APPLICATION NO.	FILING DATE	FIRST NAMED INVENTOR	ATTORNEY DOCKET NO.	CONFIRMATION NO.
10/799,898	03/12/2004	Rick Huffman	2503343-991100	8313
29585	7590	07/21/2006	EXAMINER	
DLA PIPER RUDNICK GRAY CARY US LLP 153 TOWNSEND STREET SUITE 800 SAN FRANCISCO, CA 94107-1907			GREENE, DANIEL LAWSON	
			ART UNIT	PAPER NUMBER
			3663

Office Action Summary	Application No. 10/799,898	Applicant(s) HUFFMAN, RICK	
	Examiner Daniel L. Greene Jr.	Art Unit 3663

DETAILED ACTION

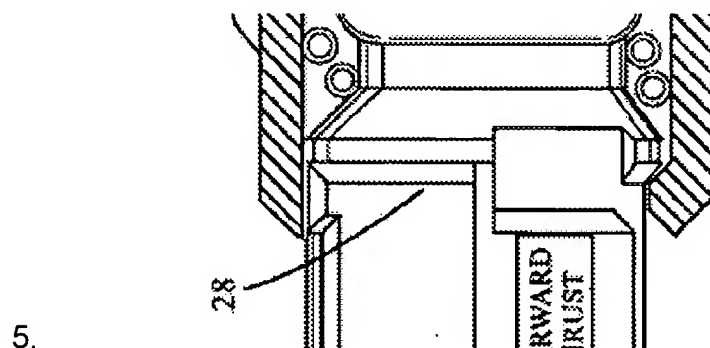
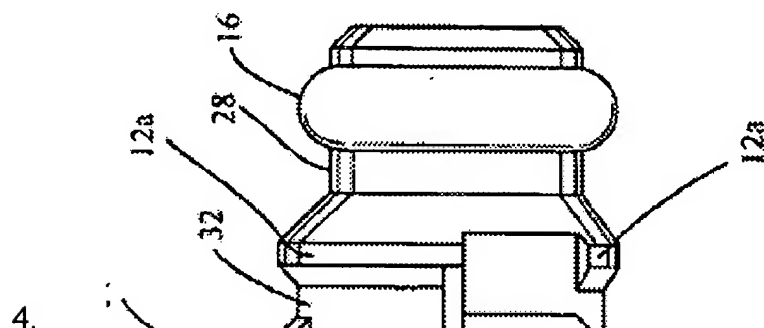
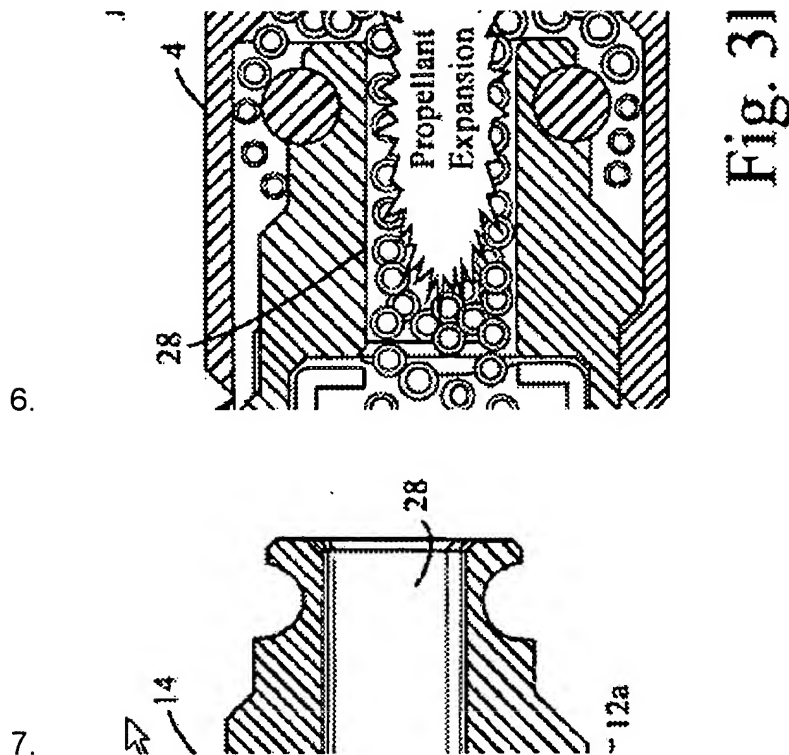
3. The drawings are objected to as failing to comply with 37 CFR 1.84(p)(4) for the reasons set forth in section 3A of the previous office action mailed 9/9/2005. Applicant's amendment to the specification is acknowledged but appears to contain new matter as explained in more detail below. Further, amendment to the specification alone does not obviate the fact that the drawings must also be corrected as said Figures have indicia indicating different parts with the same number that cannot be overcome by only amending said specification as shown in more detail below.

A review of the manner in which the specification was amended, in order to define exactly what item 28 is, when referenced to the drawings, creates doubt as to what exactly applicant is attempting to define because item 28 is a narrow cylindrical portion (page 13, last line), however the specific metes and bounds of this cylindrical portion have not been set forth. It appears that according to at least figures 2B and 3B the narrow cylindrical portion extends almost half way from the beveled tip towards the third end portion 36, however according to Figure 1D it would appear the portion only extends from the beveled end to the cog portion.

8. The drawings are still objected to for the reasons set forth in sections 3A and 3B of the 9/9/2005 Office Action because it is still unclear exactly what applicant is defining as items 28 and 32.

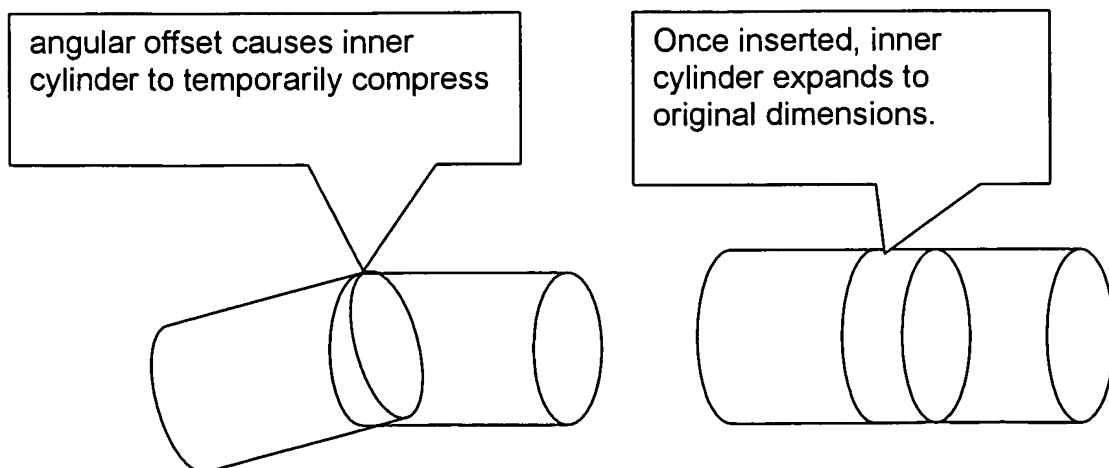
In response to applicant's argument that the references fail to show certain features of applicant's invention, it is noted that the features upon which applicant relies (i.e., partially annular) are not recited in the rejected claim(s). Although the claims are interpreted in light of the specification, limitations from the specification are not read into the claims. See *In re Van Geuns*, 988 F.2d 1181, 26 USPQ2d 1057 (Fed. Cir. 1993). Further in this regard, the instant claim language is not closed ended, i.e. the claim states "comprising...one or more protrusion portions". Clearly enough protrusion portions would surround the entire piston sleeve just as in Saxby.

Applicant's arguments are unpersuasive as applicant has not shown that the references do not teach what the examiner has stated they teach, nor has applicant shown that the examiner's reasoning for and manner of combining the teachings of the references is improper or invalid. The difference in operation of the claimed invention does not alleviate the fact that the reference contains each and every limitation found in the instant claim language.

Further, although applicant states the assembly procedure of Saxby, there is no reason they cannot be assembled by relative angular offset and compression of the inner cylinder by for example;
